ADDENDUM TO THE FINAL PROGRAM  
ENVIRONMENTAL IMPACT REPORT  
FOR BIOSOLIDS MASTER PLAN  
FOR PROJECT NO. P2-128

SCH #: 2017071026

Prepared for  
Orange County Sanitation District  
10844 Ellis Avenue  
Fountain Valley, CA 92708

December 2022

**Figure 2**  
Site Plan

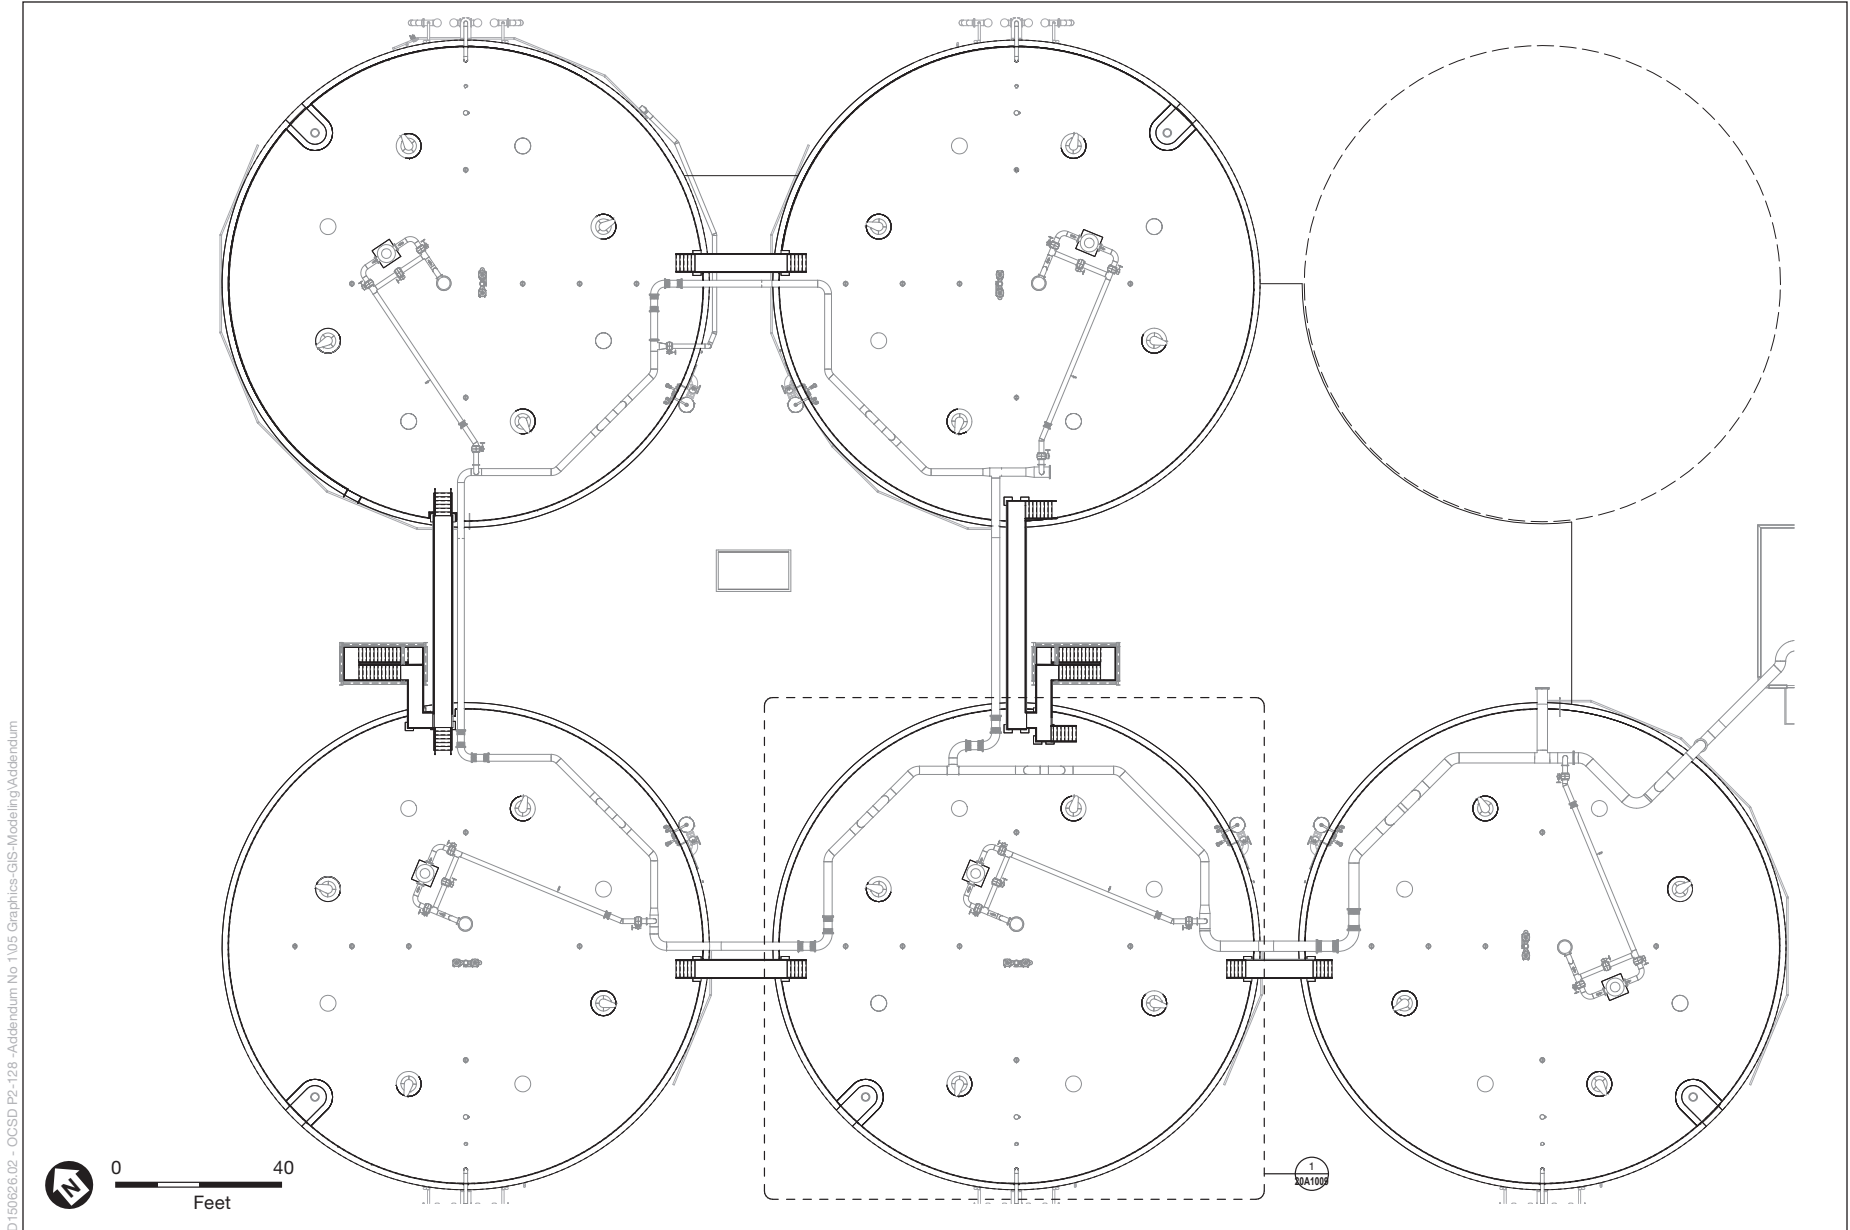
The project evaluated in the PEIR included two proposed DFF tanks that would be 33 feet wide and 30 feet tall, with a volume of 100,000 gallons each, along with a building housing the tank mixing system, digester feed pumps, and electrical control room. The Project Modifications now call for two DFF tanks, approximately 22 feet in diameter and 27 feet tall, with a volume of approximately 70,000 gallons each, along with a central mixing chamber. The DFF would be located adjacent to the thermophilic digesters. The pair of DFF tanks would include cone bottoms extending below grade. The subsequent Project designs also include a new digester electrical building to power the new DFF (including the associated odor control and chemical area) and Thermophilic Digesters C, D, and F (with space for future addition of electrical equipment for Thermophilic Digester E). The Digester Feed and CDF Electrical Building would be located on the east side of the thermophilic digesters (see Figure 2).

Similar to the project evaluated in the PEIR, the P2-128 DFF odor control facility would treat foul air from the headspace of the new DFF tanks. The DFF tanks, mixing chamber, and depressed pump pit would be constructed of cast-in-place concrete. Finally, a new chemical feed and storage area would be constructed for the DFF odor control facility at the locations identified in Figure 2, east of the DFF.

In summary, the Project Modification evaluated in this Addendum for this component includes one additional DFF mixing chamber, a modified electrical building, and a new chemical feed and storage area. Each of these new facilities would be located within the same footprint identified in the PEIR for the project as shown in Figure 2.

**Figure 3**  
Digester Plan View

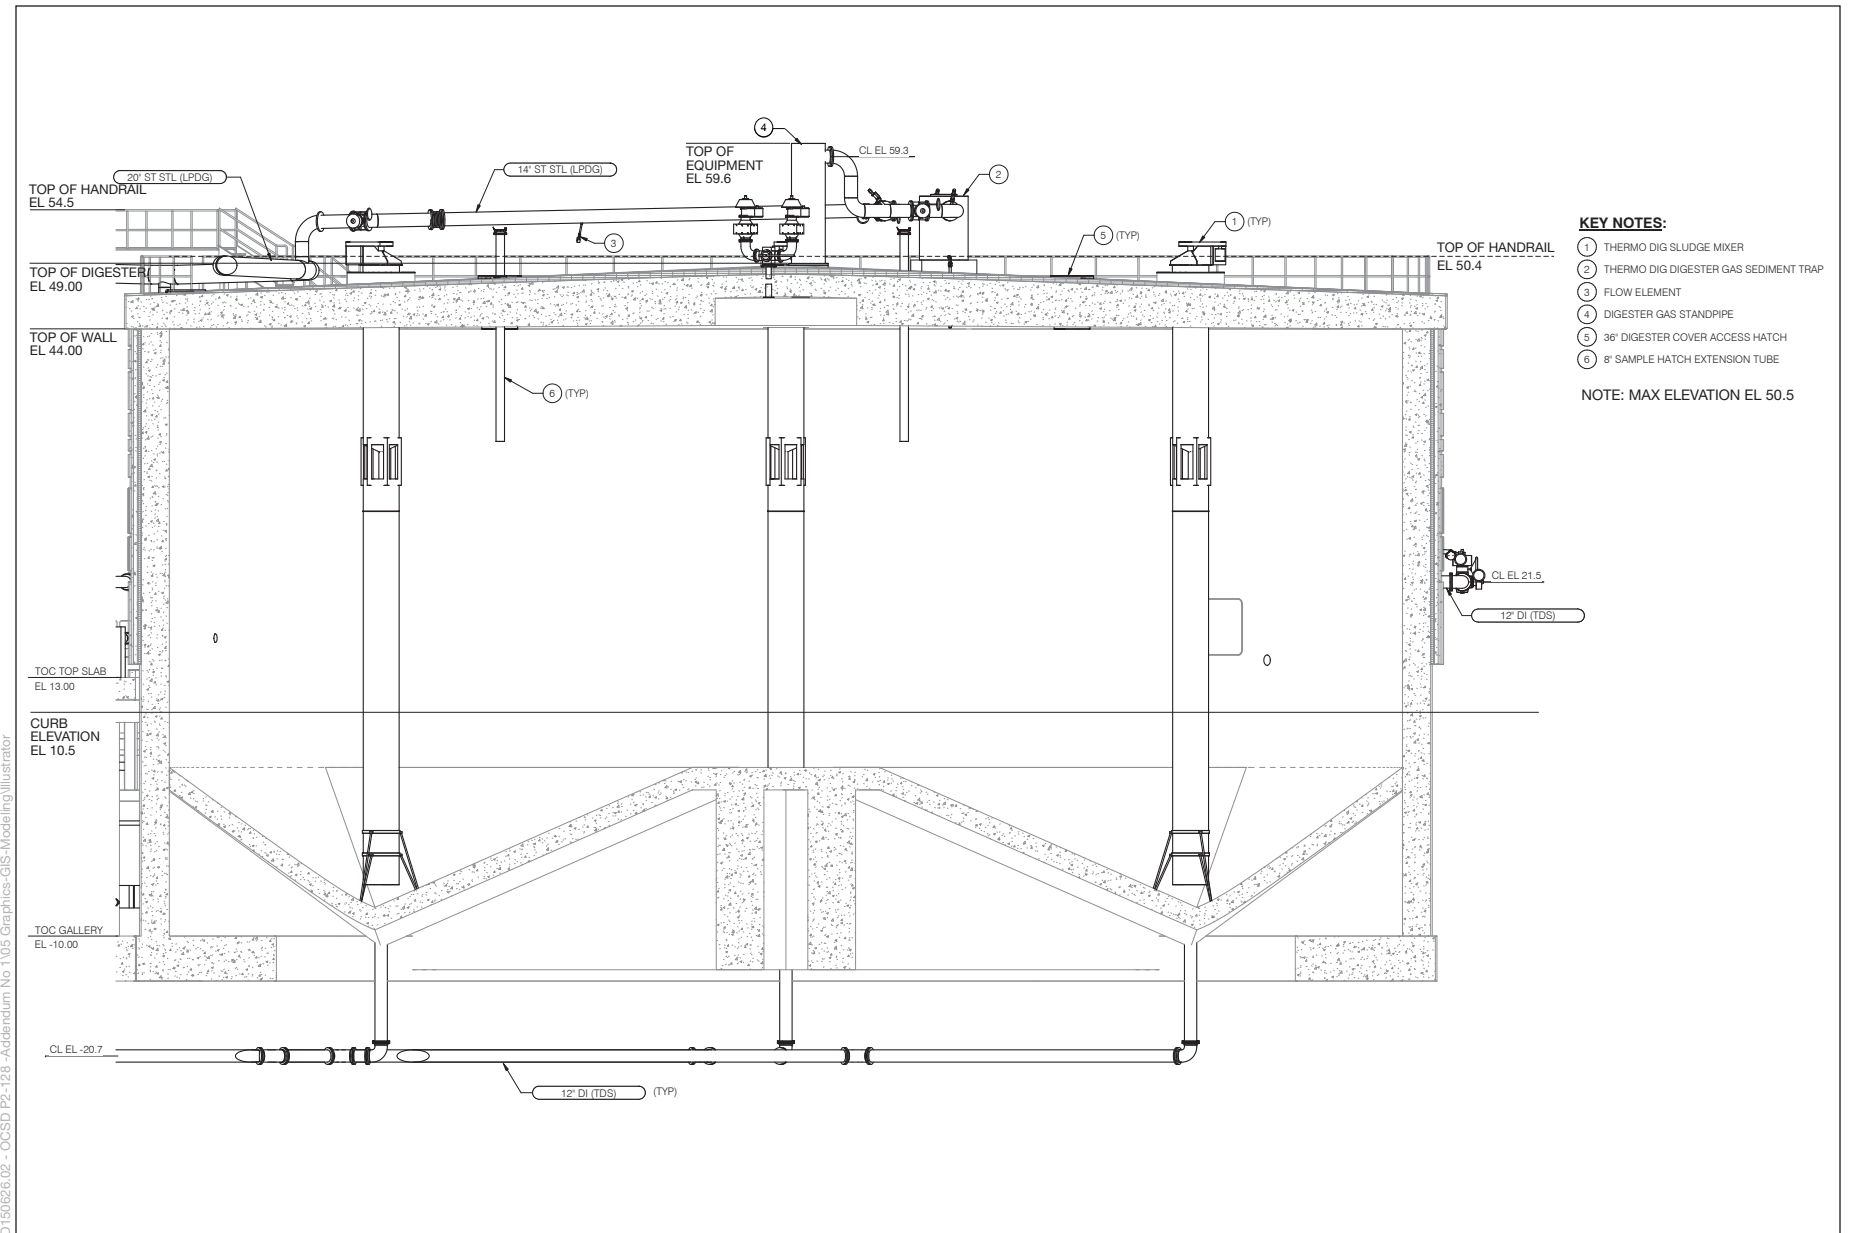
The project evaluated in the PEIR included six thermophilic digesters, with a below-grade gallery between the digesters (**Figure 3**), that would be located west of the DFF and the DFF Odor Control Facility. Subsequent designs have recommended reducing from six to five thermophilic digesters (named Thermophilic Digesters A, B, C, D, and F). The subsequent design would accommodate future construction of the 6<sup>th</sup> digester (Thermophilic Digester E), but this digester would not be constructed at this time. The thermophilic digesters would be partially buried and would be constructed of cast-in-place concrete, including the foundation, floor, wall, and roof. The PEIR evaluated digesters that would be 110 feet in diameter and 40 feet tall. In the subsequent designs, each digester would be 110 feet in inner diameter and 40 feet tall (**Figure 4**).

In summary, the Project Modification evaluated in this Addendum for this component includes the reduction from six to five thermophilic digesters of similar size. The facilities would be located within the same footprint identified in the PEIR for the project as shown in Figure 2.

**Figure 5**  
Construction Stages

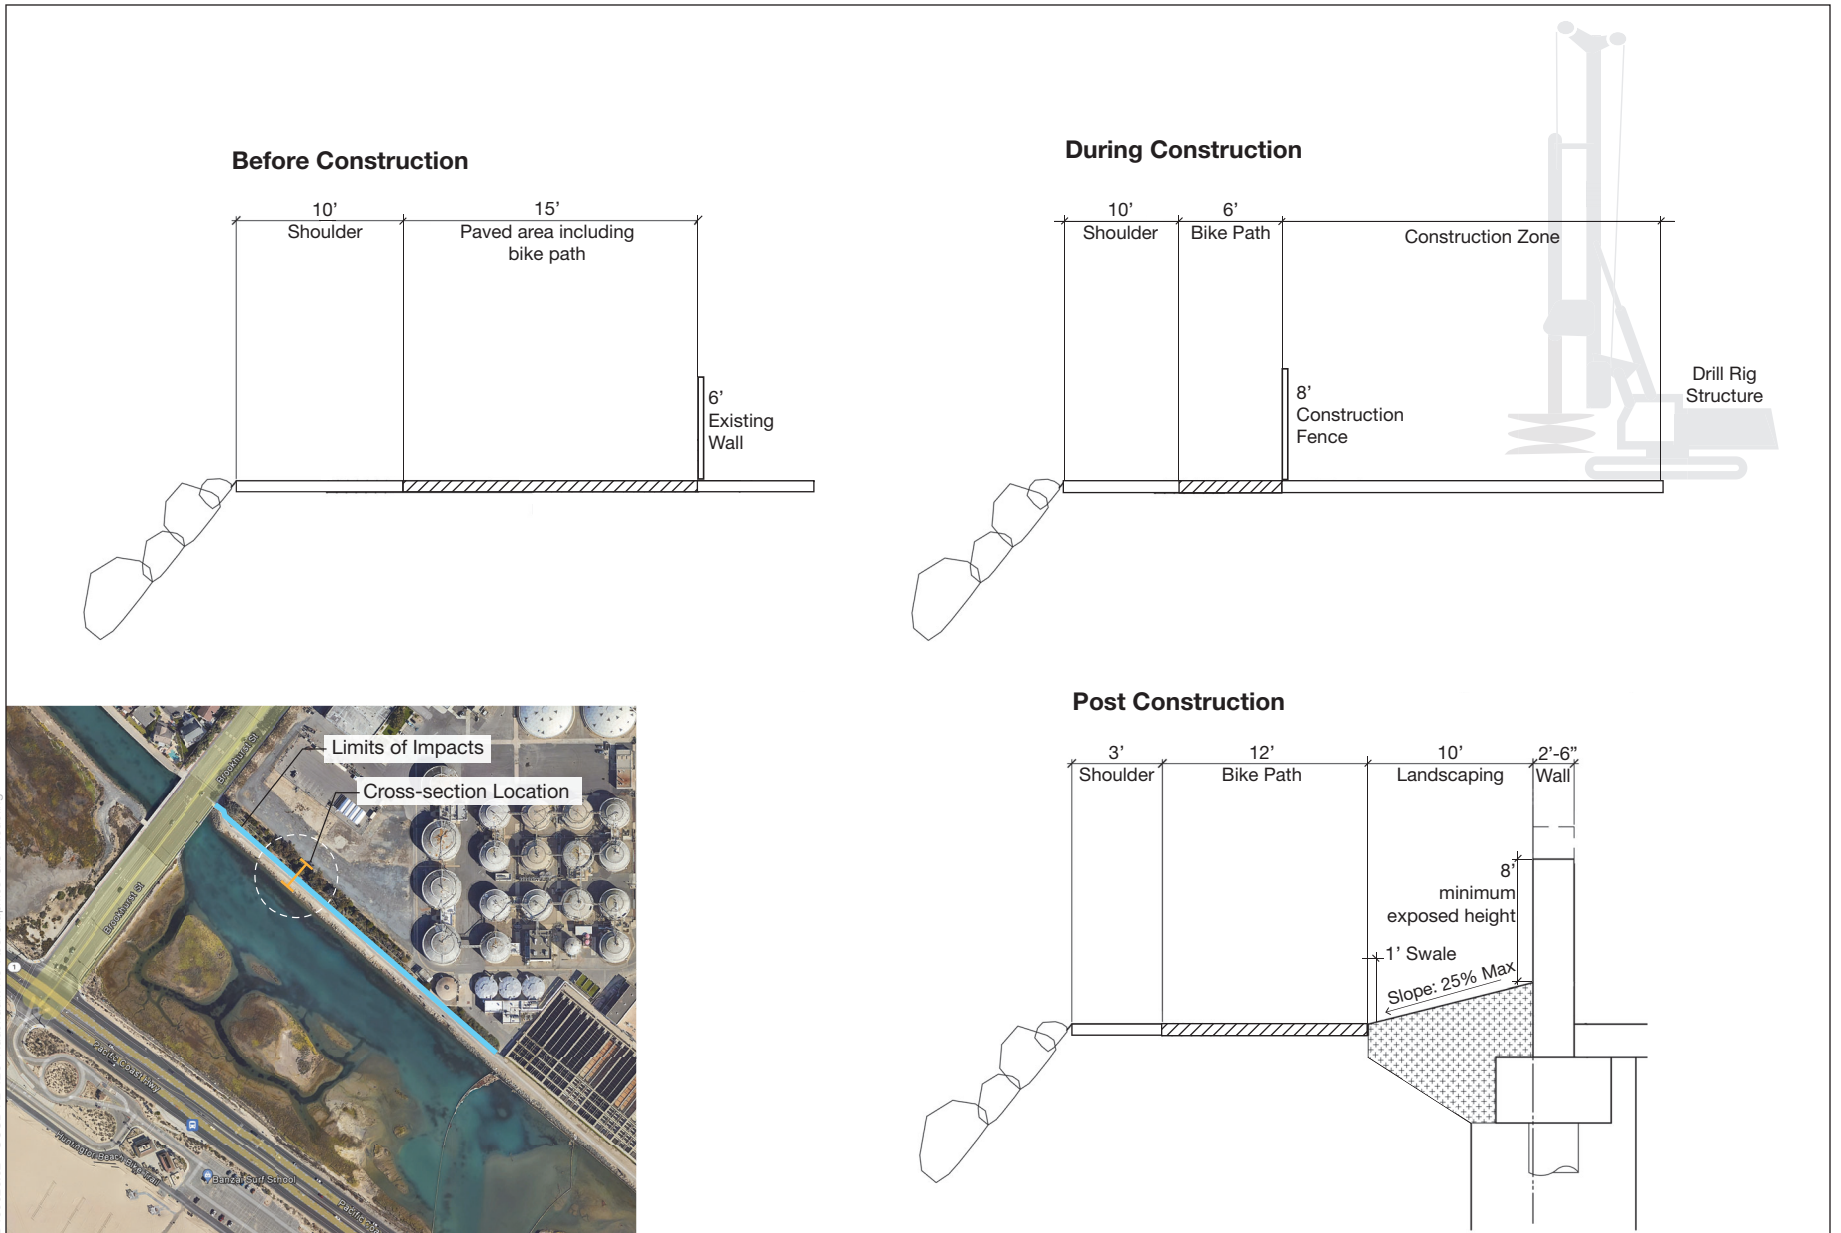
After the Project Modifications are completed, the bike path will be restored to two 6-foot-wide travel lanes (**Figure 5**). Previous designs had included 10- to 15-foot-high vegetation along the Talbert Marsh wall; however, under the proposed modification the wall would have a combination of various shrubs and ground cover, including California Sagebrush, Coyote Brush, and California Buckwheat, running adjacent to the existing bike path. The low-lying vegetation is designed to reduce the opportunity for predatory raptors to perch near the Talbert Marsh.

**Figure 7**  
Pre-and Post-Construction

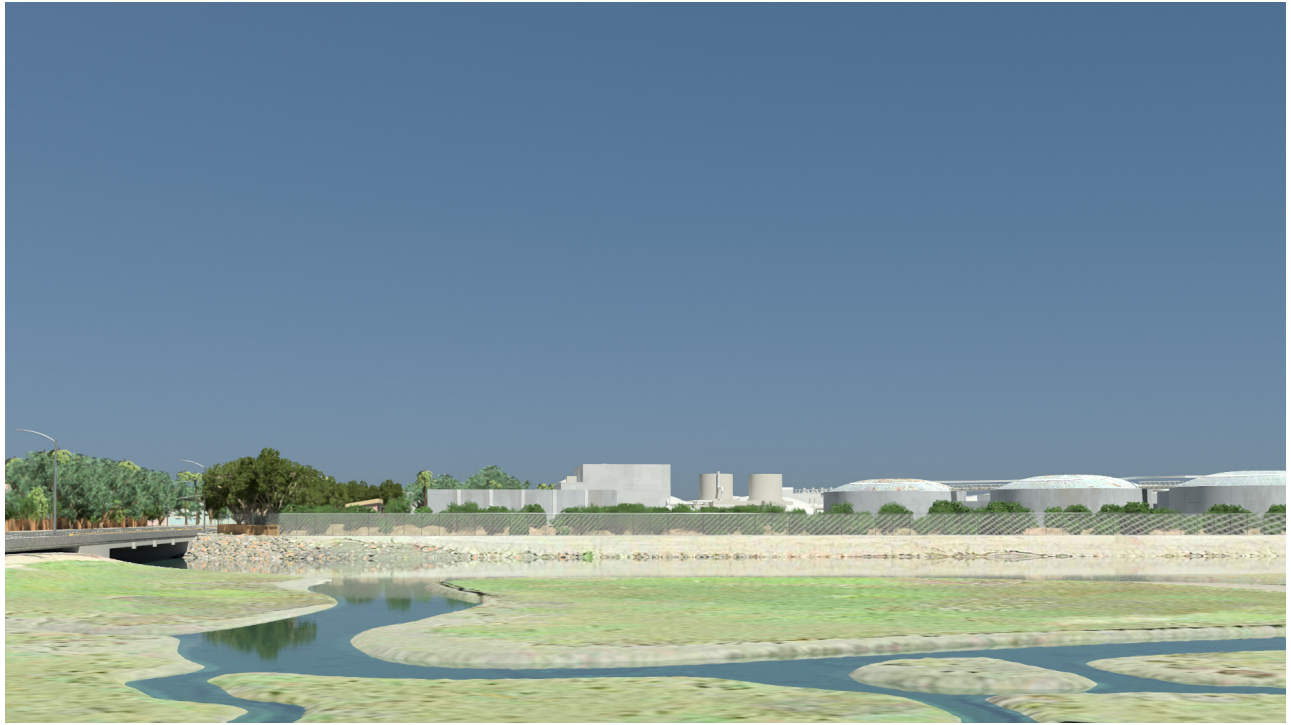
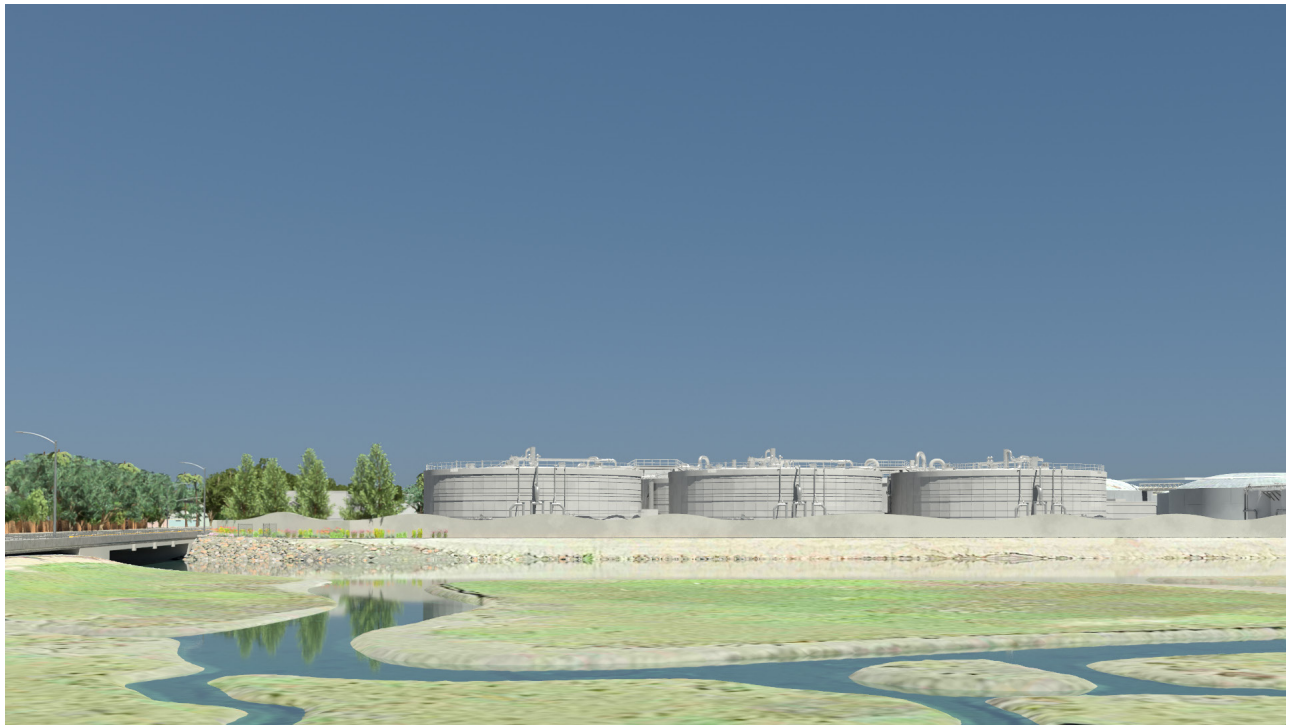
The proposed Project Modifications to the TPAD facilities would be 40 feet tall at the roof level with an additional 10 feet of appurtenant equipment. The additional roof-top equipment was not expressly identified in the PEIR. However, the Local Coastal Plan (LCP) allows for buildings up to 40 feet in height with appurtenant facilities on the roof extending an additional 10 feet requiring a conditional use permit (CUP). As a result, the Project Modifications would be consistent with the LCP with an approved CUP. Similar to the project evaluated in the PEIR, the proposed 40-foot-tall digesters will be in the same location and views of the digesters will be visible from public streets such as Brookhurst Street and the PCH. As a result, the Project Modifications would be consistent with the assumptions in the PEIR and would not alter the conclusions of the PEIR.

The PEIR evaluated the perimeter screening on the southern border of the Plant that included revised landscaping, maintaining vegetation up to 15 feet high. The proposed Project Modifications will result in a new wall on the southern edge of the treatment plant instead of the proposed vegetated berm. Construction of the new wall will require CDSM methods requiring soil-mixing rigs that could be up to approximately 50 feet tall. These rigs were not expressly identified in the PEIR. However, the appearance of the rigs will be similar to the cranes identified and evaluated in the PEIR. As a result, the new construction methods required by the Project Modifications will not alter the conclusions of the PEIR. The temporary construction equipment required for the Project Modifications will have a less than significant impact to scenic views.

Once constructed, the new wall will be visible from public views along Brookhurst, the bike path, and PCH. The new wall will partially obscure views of the treatment plant but to a lesser extent than assumed in the PEIR. **Figure 7** shows the current condition of the Plant No. 2 site and a simulation showing the new digesters and wall. Once constructed, the new wall will be visible from both Brookhurst Street and PCH. The replacement of the existing chain link fence with a decorative wall and landscaping along the southern perimeter of the Plant will change the appearance of the southern edge of the treatment plant, but it will still partially obscure the existing industrial treatment facility. Scenic vistas will not be blocked, and the new facility will resemble the existing treatment plant infrastructure. As a result, the Project Modifications will not alter the conclusions of the PEIR and will not have a substantial adverse effect on scenic vistas.

Once constructed, the new wall will be visible from public views from the Brookhurst Street, the bike path, and PCH. Figure 7 shows the current condition of the Plant No. 2 site and a simulation showing the new digesters and wall. Once constructed, the new digesters and wall will be visible from both Brookhurst Street and PCH. The replacement of the existing chain link fence with a decorative wall and landscaping along the southern perimeter of the Plant will change the appearance of the southern edge of the treatment plant, but will not add new structures that will be inconsistent with the existing visual character. The wall will partially obscure the industrial treatment facility, similar to the existing conditions. As a result, the new perimeter wall designs will not have a substantial adverse effect on visual character.
